**Lindfield Learning Village**

Traffic and Transport Assessment -  
SEARs Comment Response

Issue | 20 November 2017

Figure 1: Proposed bus setdown using existing structure, walkway extended to inside of existing structure

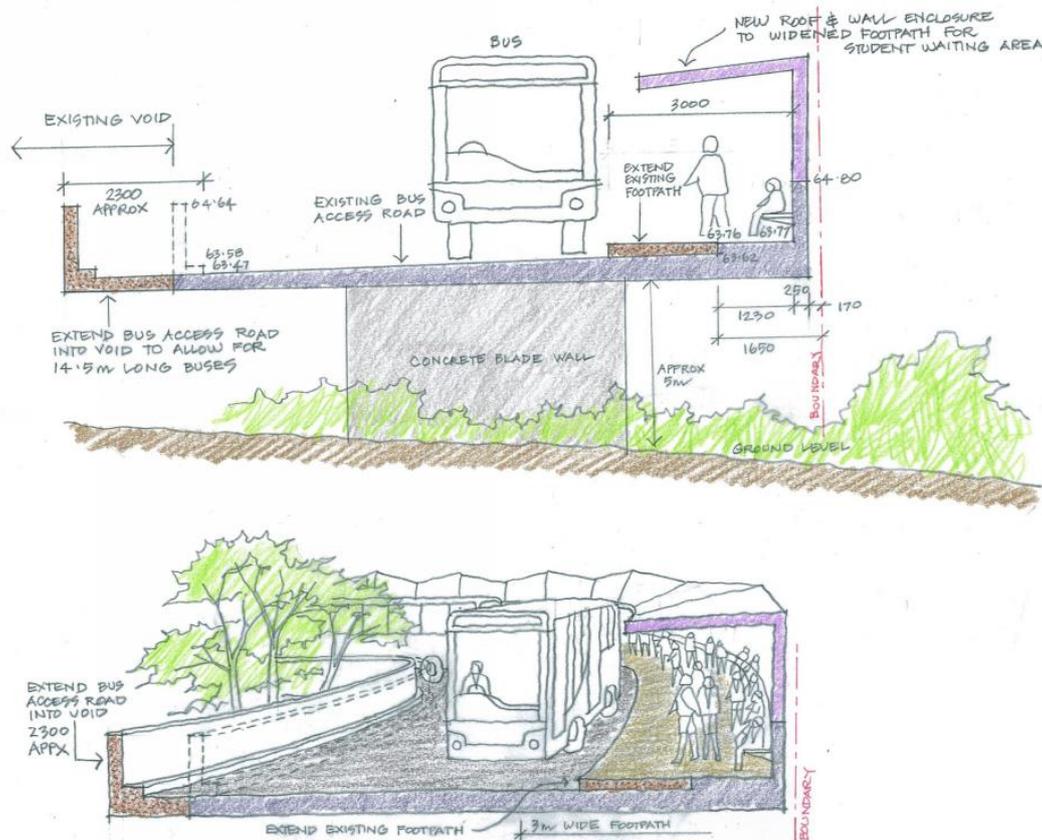
R4	[2.2] Buses using the bus bay do not appear to have enough clearance to safely navigate the bus bay without rubbing up against concrete walls or pedestrian fences. The 600mm body clearance has not been achieved.	Please refer to revised swept paths in Appendix A.

R17	<p><b>Bus Stop Design</b></p> <p><b>Comment</b></p> <p>It is likely that a number of school buses would be using the proposed bus bay at the same time. Due to the curvature and dimensions of the current design, no buses will be able to overtake other buses and/or exit their respective bus bay if there were other buses stopped at any other stops. Furthermore, the curved design would potentially pose a safety risk for children and less mobile patrons as the bus doors would open directly onto the road rather than the footpath.</p> <p><b>Recommendation</b></p> <p>TfNSW requests that the proposed bus stop design is revised or relocated having regard for the above comments. TfNSW advises that the existing bus bay would potentially be more suited to a pick-up and dropoff location for motor vehicles.</p>	<p>Refer to Section 2.2</p>

R22	[4.1.3] Eton Road Bus Bay - the proposed widening of the footpath in the Eton Road bus bay is supported, to cater for the expected numbers of students, although it should be clarified whether the proposed footpath width is adequate if the mode split to buses increases towards the levels currently experienced at Killara High School. There should also be a requirement to extend and widen the existing bus shelter/canopy to provide weather protection, and to provide adequate lighting in and around the shelters (for after-hours/evening events, so that dedicated shuttle bus services can be implemented if necessary).  There is no identified path between the Eton Road bus bay and the main school building, which is expected to be the principal connection for students walking between the bus stop and the main school building. This path should be wide enough to cater for expected student movements and be adequately lit (for afterhours/evening events).	See Section 2.2 for bus bay design.

To improve student queuing at the bus bay and to retain the existing roadway for bus turning, an alternative design with a pedestrian walkway extended to the inside of the existing structure is being investigated, illustrated in Figure 1. The proposed design would have a three-metre-wide footpath.

The existing central void is also proposed to be cut back by extending the bus access road into the void. This is to allow the 14.5 metre buses to negotiate the bend with sufficient clearances, with an indicative plan and swept paths shown in Figure 3.

This would be wide enough to contain queuing zones for the five bus positions and a bypass route for passengers to walk around to the appropriate bus location. Buses will be scheduled to arrive prior to the pick-up time and be waiting for the students to arrive. Students will then have a clear line of sight to each bus and join the relevant boarding queue.

Figure 6: Stage 1 – No upgrades and no staggered start times, Pacific Highway / Grosvenor Road intersection, Stage 1 traffic modelling results assuming the indicative school catchment is used, with no staggered start times

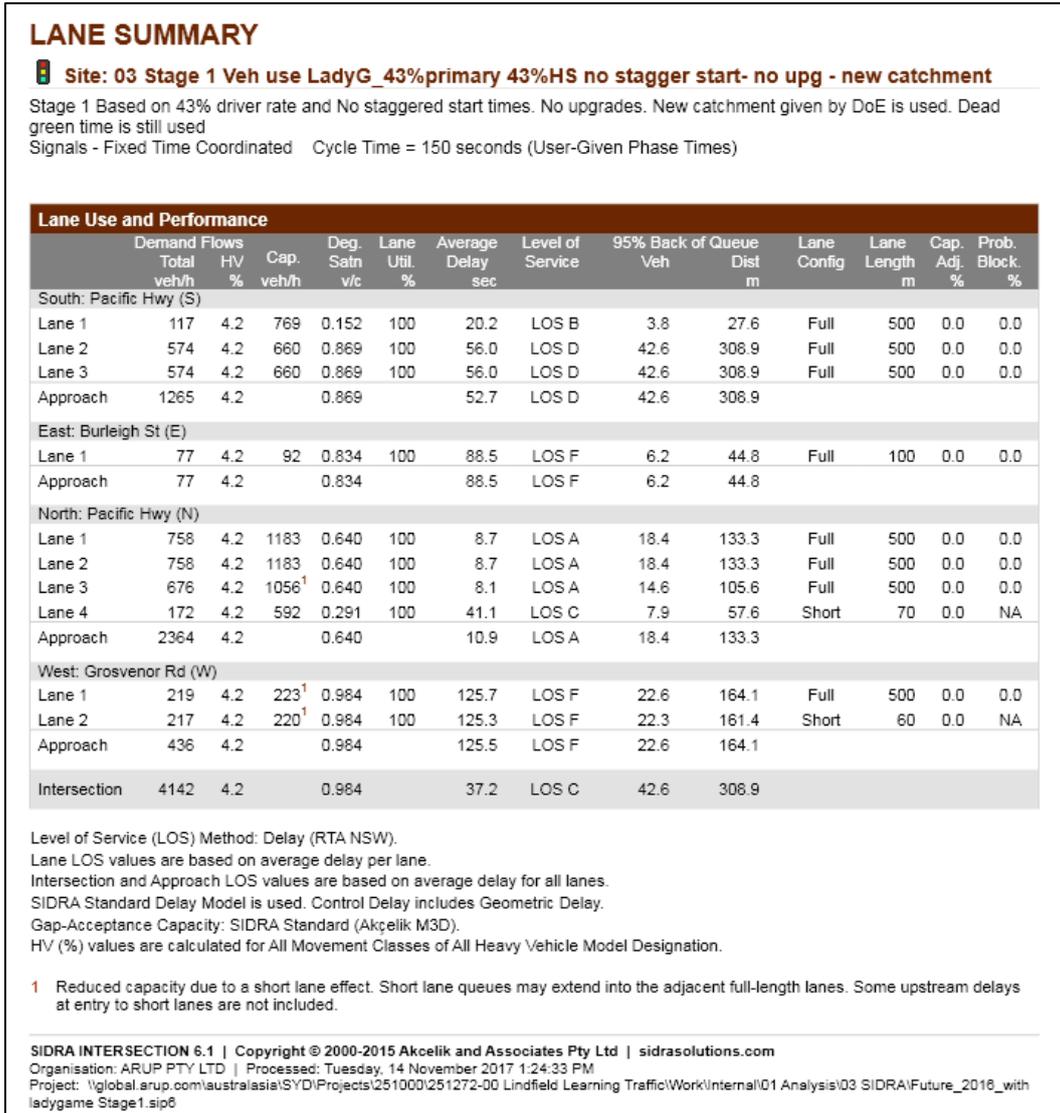
R12	[8] It is not acceptable to remove the bus stop on Pacific Highway to facilitate right turn extension. Roads and Maritime requires further information regarding the impacts of extending the Pacific Highway right turn lane into Grosvenor Road without removing the existing bus stop:	The initial traffic distribution assumptions provided in the TTA were based on all traffic from the north west accessing the site via the Pacific Highway. Based on the almost finalised draft boundary amendments to accommodate new schools recently received from the Department of Education, we have reassessed the routes and traffic has been reassigned with only 9% of the traffic using the Pacific Highway to turn right to access the site.
R13	[8.1] A civil investigation incorporating the property impacts and a cost estimate of works (including utility relocation).	Revised modelling results of the Pacific Highway / Grosvenor Road intersection shows that if traffic uses the Lady Game Drive / Grosvenor Road intersection to access the site, the Pacific Highway intersection would operate at an efficient level of service C.

R14	[8.2] The modelling assessment indicates that the proposed right turn bay extension to 170m is shorter than the future queue length of 200m. Roads and Maritime raises concerns that the queue will regularly block through traffic on the Pacific Highway and cause significant congestion.	Considering that Stage 1 of the project is for half of the Stage 2 number of Students (1,050) there will be no need to upgrade the Pacific Highway/Gosvenor Road intersection in Stage 1.
R15	[9] Roads and Maritime requests the applicant to investigate the following congestion alleviating upgrades.	For the Lady Game Drive intersection, the new distribution has 12% of school traffic utilising this intersection. These additional vehicles will not impact on the operation of this intersection as queuing is influenced by the downstream road operations. The additional vehicles will join the southbound queue and leave to turn left at Grosvenor Road, hence they will not impact the downstream source of queuing.  Please refer to section 4.1 for modelling clarification and upgrade options in section 3.5.

Based on the modelling results, the Pacific Highway / Grosvenor Road would continue to perform at an efficient level of service C, with the opening of Stage 1 of the learning village. According to the model's 95<sup>th</sup> %ile queue, the 70m right turn bay from Pacific Highway into Grosvenor Road are predicted to operate efficiently with no occurrence of a spillover.

It should be noted however that the western approach of Grosvenor Road is predicted to reduce in performance and at an average delay of 125 seconds (existing 77 seconds). The model predicts a 95<sup>th</sup> %ile queue length of 126 metres along Grosvenor Road. This is due to the high proportion of vehicles coming from the southeast, and would exit the learning village by turning right from Grosvenor Road onto Pacific Highway. The model has been set up to prioritise the state classified Pacific Highway, therefore less green time is given to the minor approach of Grosvenor Road. Vehicles who experience high delays using Grosvenor Road could choose to use alternate right turn arrangements located at the Shirley Road / Pacific Highway intersection, however this option is not modelled to assess a conservative estimate.

The south approach (non-peak direction) along the Pacific Highway is also expected to reduce in performance from a LoS C to a still efficient LoS D. The peak southbound direction is predicted to perform efficiently according to the model.

Figure 21: Stage 2 Revised traffic distribution SIDRA results, Pacific Highway / Grosvenor Road, with vehicles now using Lady Game Drive. A 25% approach from each direction

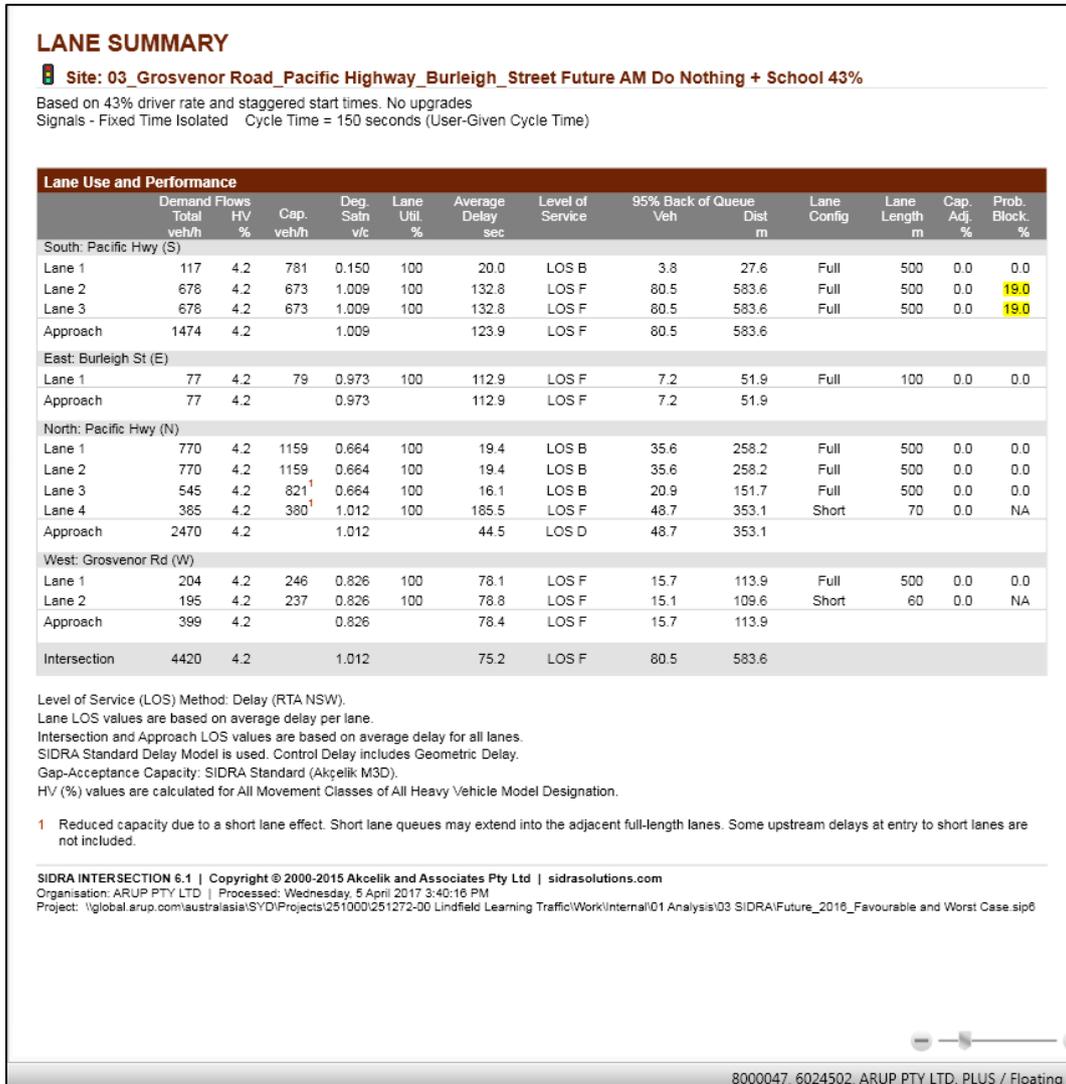
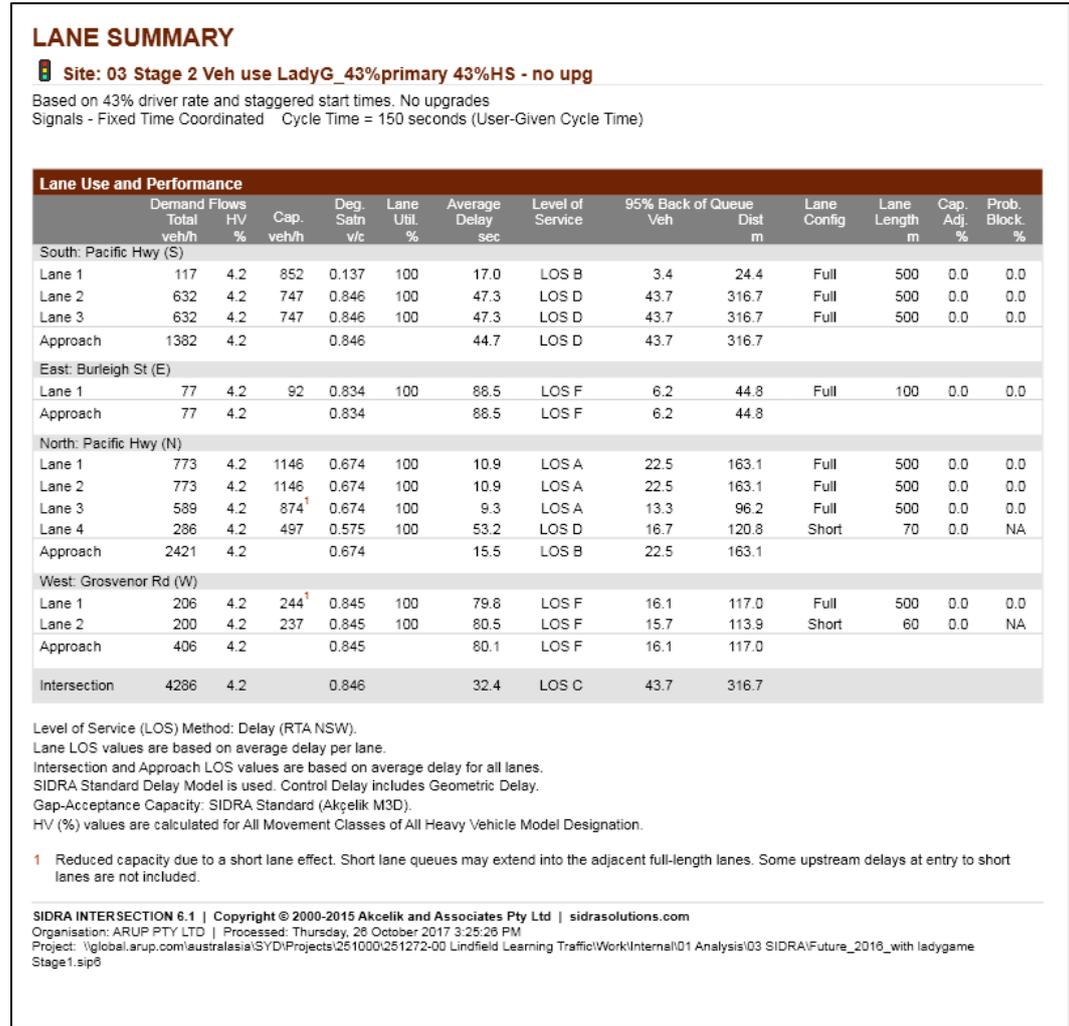
R26	[4.4.1] Traffic distribution - The assessment suggests that vehicles arriving in the morning peak to the site from Lady	Arup agrees with these findings with revised modelling discussed in section 4.2 of this report.

Based on the assumption that traffic would use Lady Game Drive and the modelling results, the Pacific Highway / Grosvenor Road would not require any additional upgrades to the intersection. The upgrades previously proposed in the TTA have assumed that none of the traffic generated by the site would use Lady Game Drive.

As such it can be concluded that Lady Game Drive is a key access to the school and is a more favourable point of entry than the Pacific Highway for vehicles travelling from the west. With a more distributed traffic assignment to the learning village, the overall intersection performance would be at an efficient level. However, the model predicts a 95%ile worst queue of 120 metres along the right turn bay of the Pacific Highway. This result considers the effects of dead

The model also indicates a 50%ile worst queue of 70 metres. This indicates that the queue would not spillover 50% of the time. The model also indicates that there is also a 0% probability of lane blockage, indicating the adjacent lanes are able to accommodate the through movements despite a spillover from the right turn bay.

Figure 28: Double right turn bay option

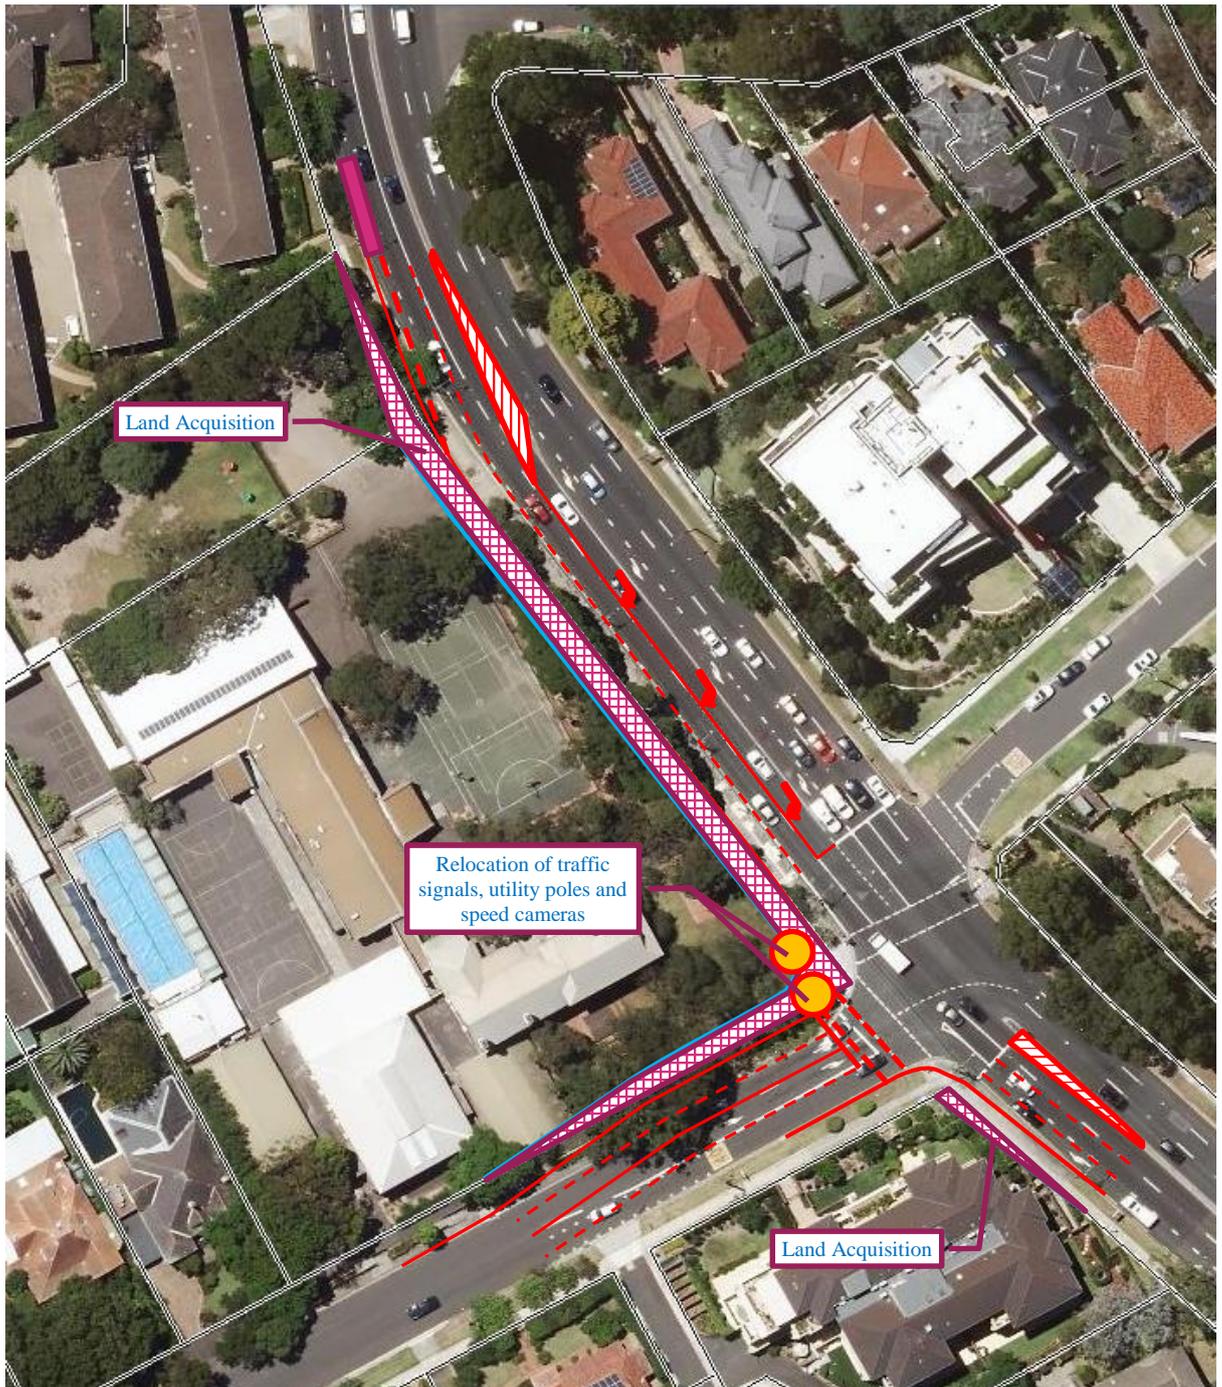
Option 3	Dual right turn bay option. The meeting was agreeable that this option may not provide enough right turn benefit due to the limited merge in Grosvenor Road.	Nil
<b>Other Issues</b>		
Lady Game Drive	RMS has commented that future upgrades to Lady Game Drive are still indicative. It would consist of drainage and safety upgrades rather than traffic capacity improvements.	Nil
Footpaths and cycleways	It was agreed that existing footpaths were inadequate. Footpaths should be provided to at least one side of the road at key pedestrian routes, ideally set back from the kerb line. Council is to be consulted.	DoE, Savills, DesignInc
School catchment	DPE asked if the school catchment has been decided. Savills advised that it is still being determined.	Nil

Option 3 (not part of the Lindfield Learning Village development) proposes two 70 metre right turn bays into Grosvenor Road, shown in Figure 28. Modelling indicates that there would be sufficient storage space within the right turn bays upon completion of the school. This is however the most expensive option given the large requirement of land acquisition and civil works required to facilitate for footpaths on the western side of the Pacific Highway and Grosvenor Road. This option would also require widening Grosvenor Road to facilitate two exit lanes.
